World Forum for Harmonization of Vehicle Regulations

Working Party on Noise and Tyres

Tyres: UN Regulation No. 30 (Tyres for passenger cars and their trailers)**Proposal for a Supplement to the 02 series of amendments to
UN Regulation No. 30****Submitted by the experts from the European Tyre and Rim Technical
Organisation***

Annex 3,

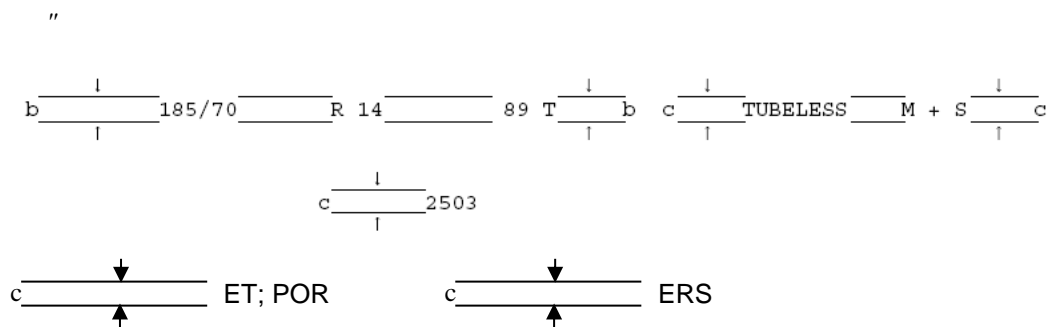
Paragraph 1., replace the figure by the following:

b = 6 mm (min.)

c = 4 mm (min.)"

Figure
Steps in the test procedure (source: Figure 4 from ISO 16992:2018)

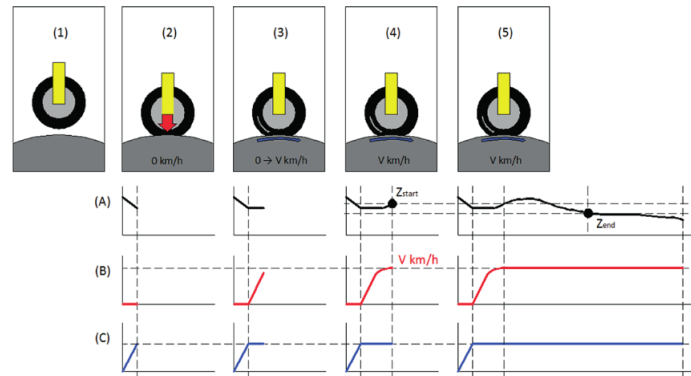
5. The description of the load/speed tests for run flat and EMT tyres is revised with the aim to clarify the succession of steps in the test procedure, so that it is aligned with the standard ISO 16992.

6. For the conduction of the test, it is important that the deflection section heights are measured while the tyre-and-wheel assembly is running at the test speed, because the deflection heights change when the speed is changed due to the effect of centrifugal forces.
